City of Biddeford
Planning Board
May 03, 2023 6:00 PM City Hall
Council Chambers, & Zoom
<https://biddeford.zoom.us/j/99254547167?pwd=Z2t5OFo5L01EL3Z3M1UxL2JFYzA1UT09>
Webinar ID 992 5454 7167 Passcode 514787

STATUS: Planning Board, Wednesday, May 3, 2023, 6:00 PM, City Council Chambers & Zoom

- 7.E. 2023.22 Site Plan Application for Brown Dog Carriers to build a commercial facility for company headquarters for their trucking company. Property is located on Landry Street (Tax Map 74, Lots 11 & 10-2) in the Industrial 2 zone.

SHEET
1

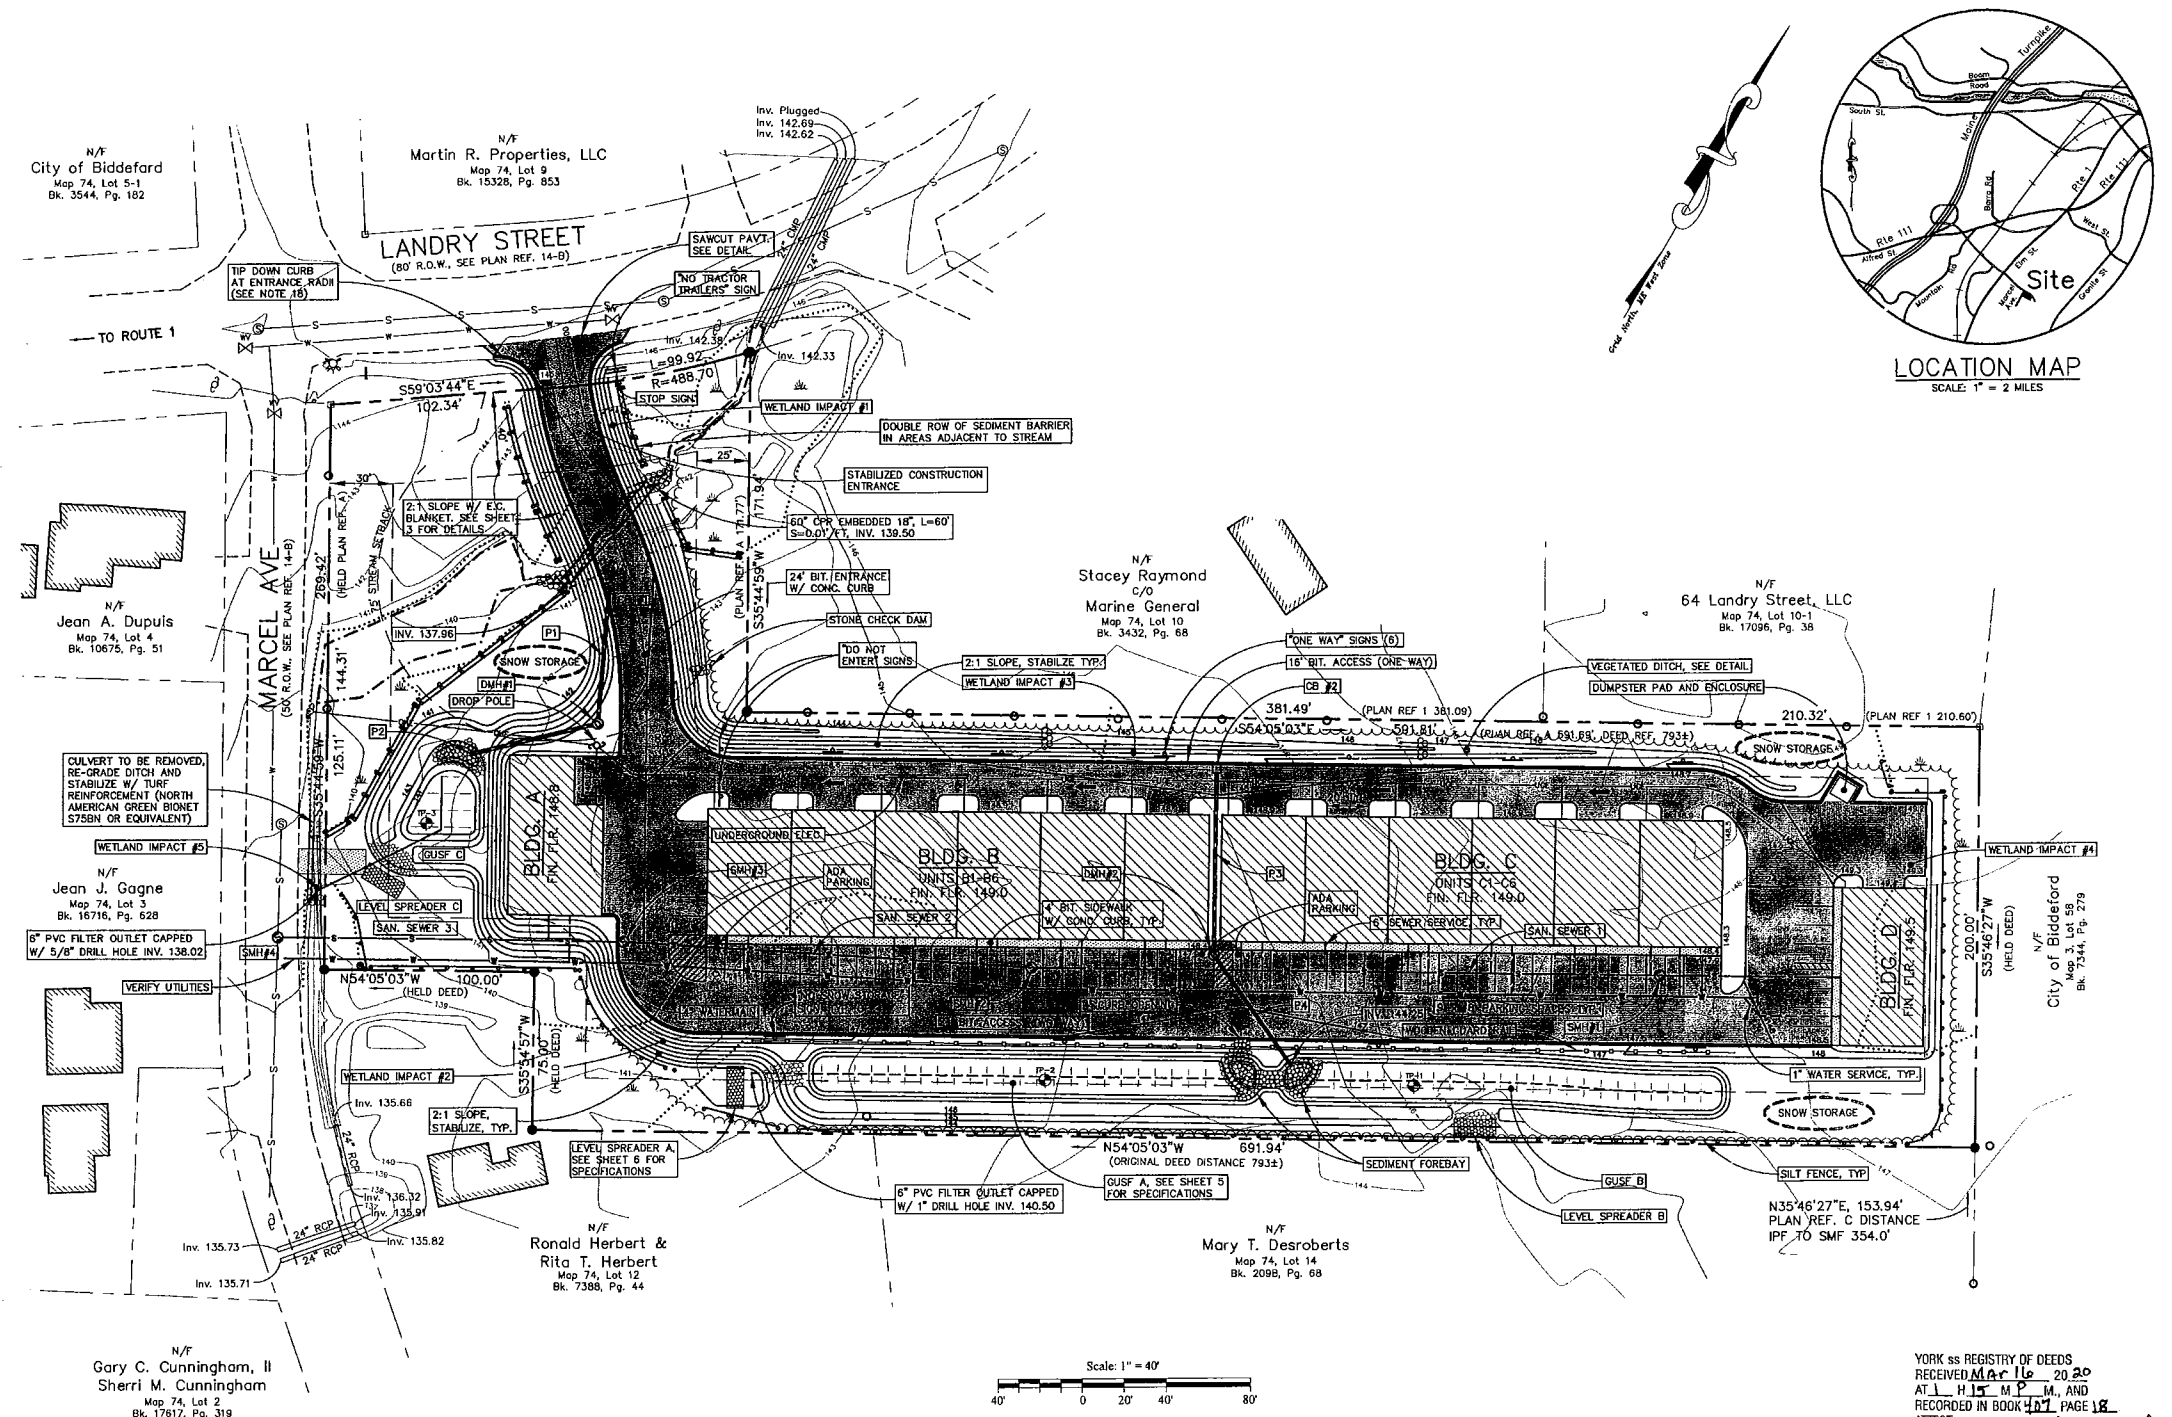
1. Sheet 1 – Preliminary Site Plan
 - a. The cover letter indicates a 6,000 sf building is proposed, the plan shows a 5,280 sf building, and the parking calculation shows a requirement of 1 space per 200 sf for a total of 20 spaces. This should be clarified.

SHEET
2

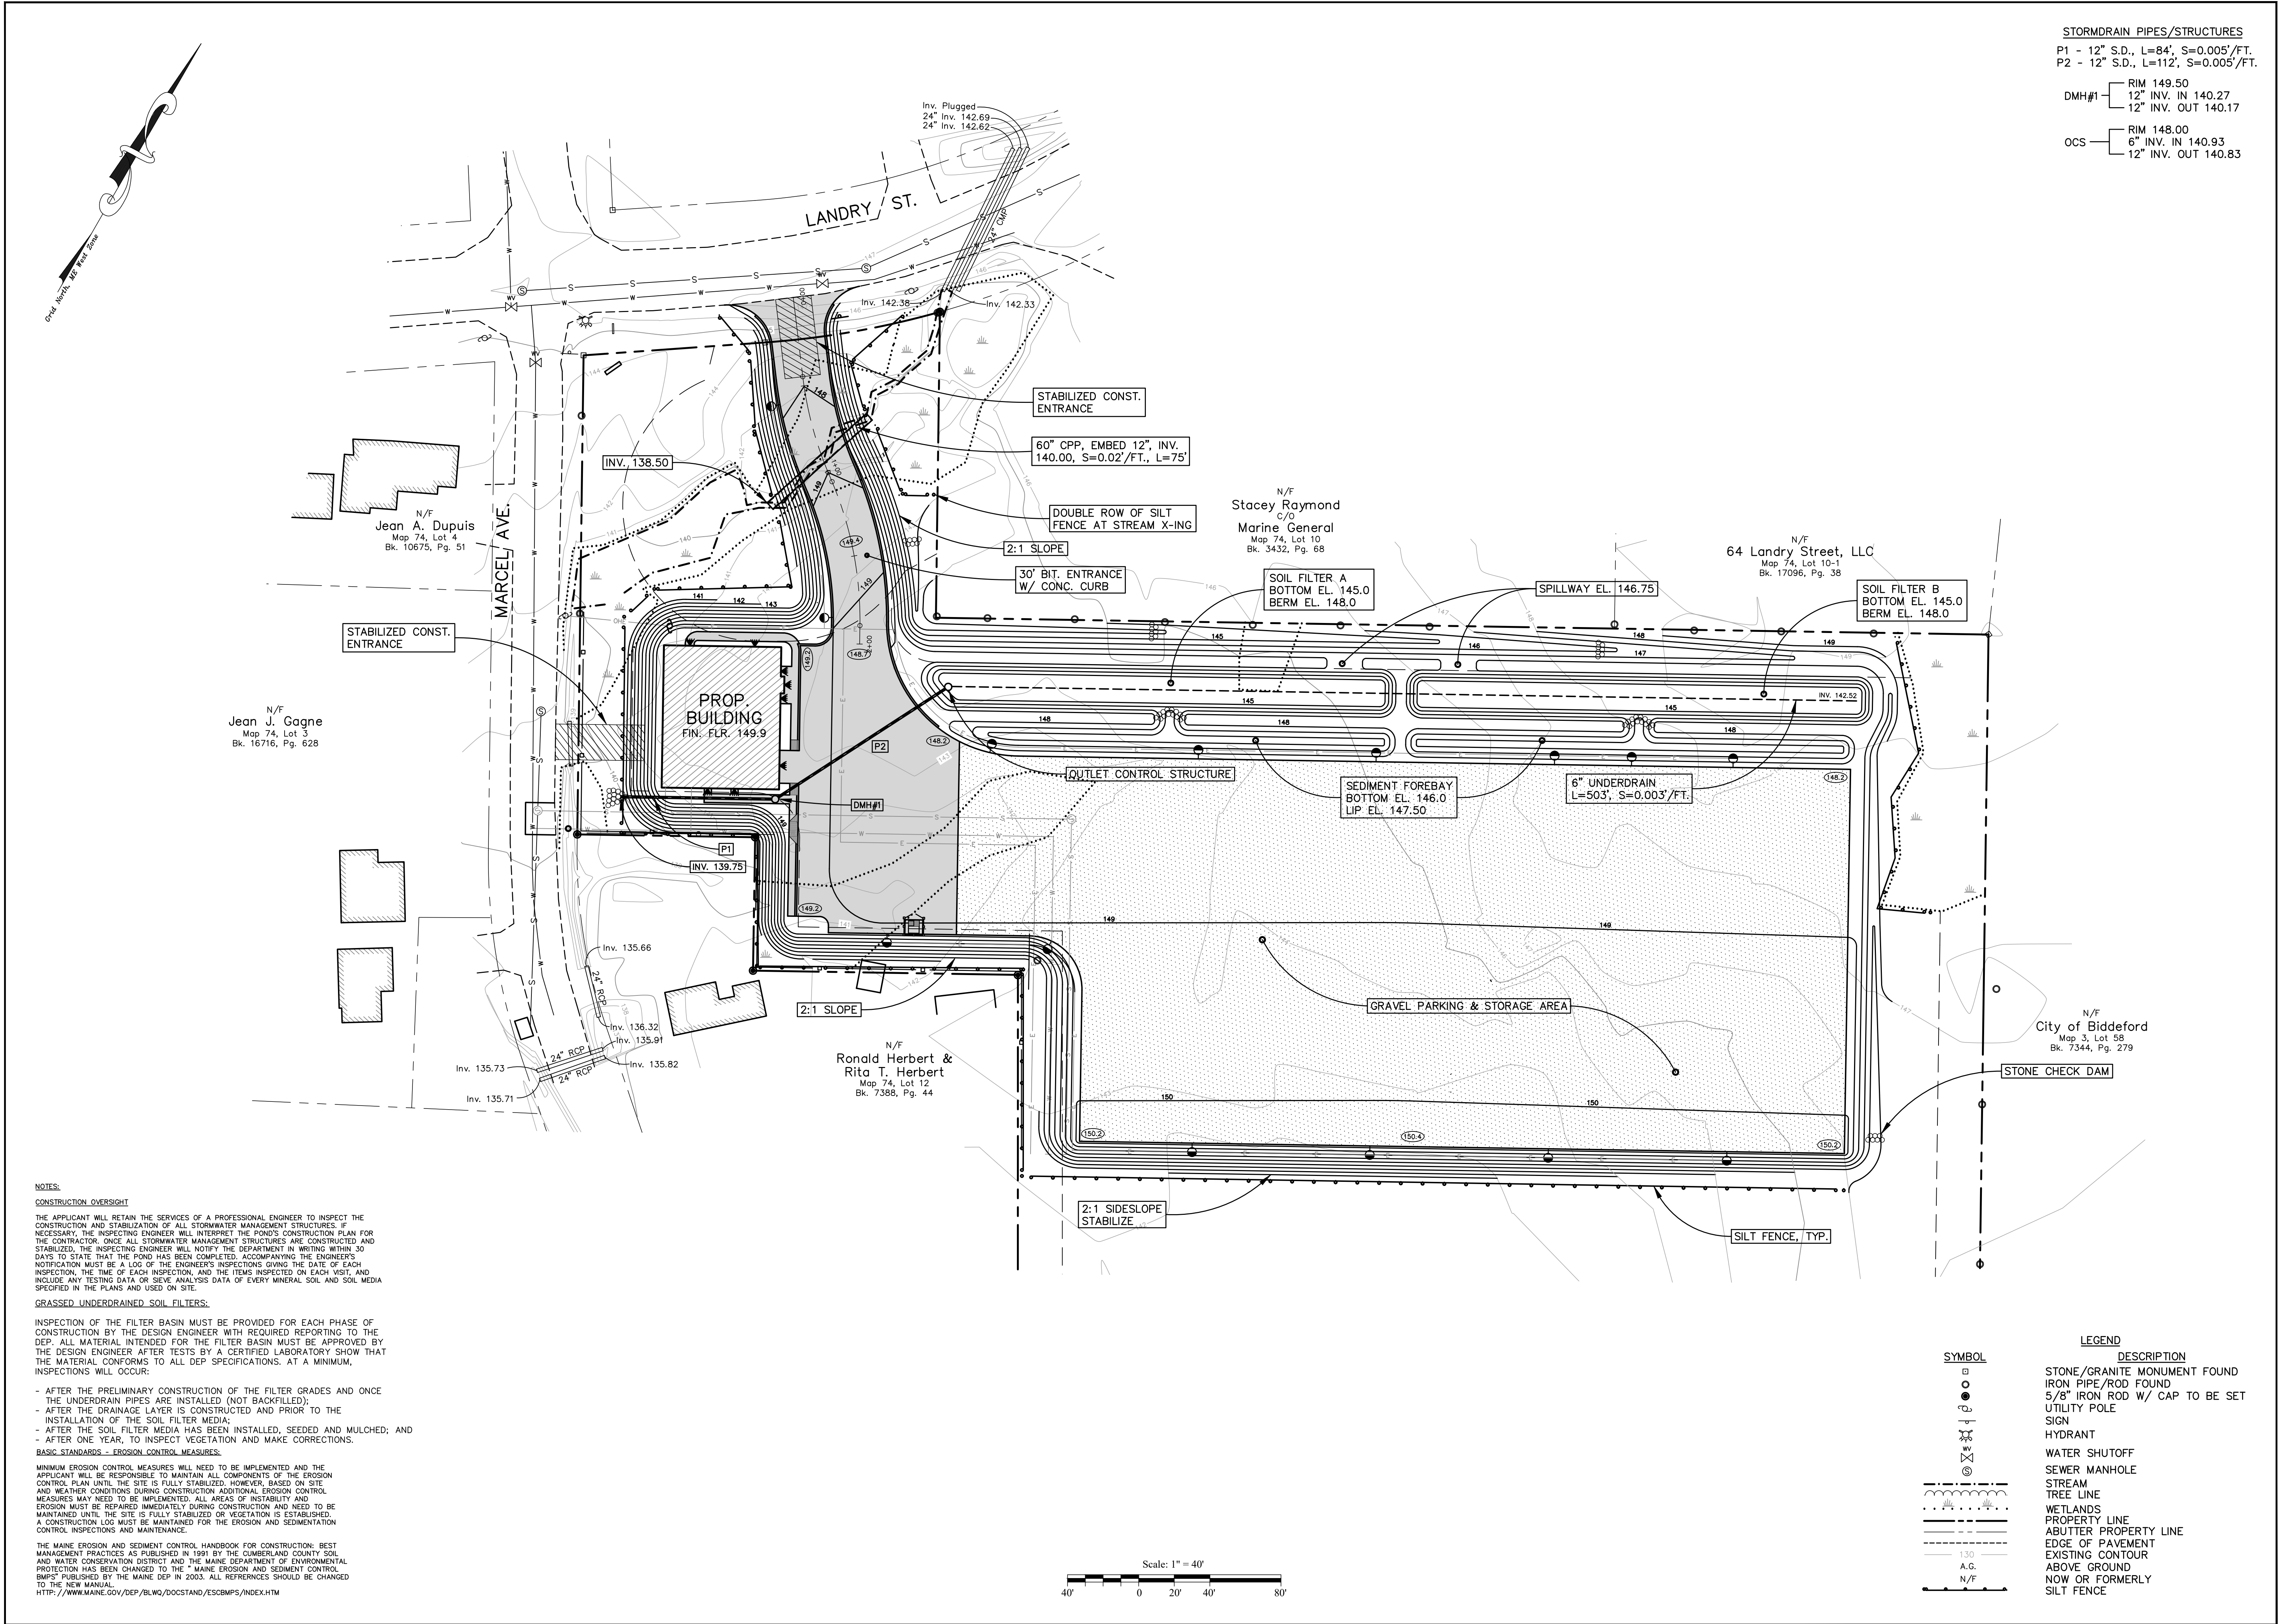
- f. Is the dumpster enclosure permitted in the side setback?
2. Sheet 2 – Grading and Erosion Control Plan
 - a. Why are two stabilized construction entrances shown. Given the residential nature and current condition of Marcel Avenue, it may be preferable for construction traffic to utilize only Landry Street.
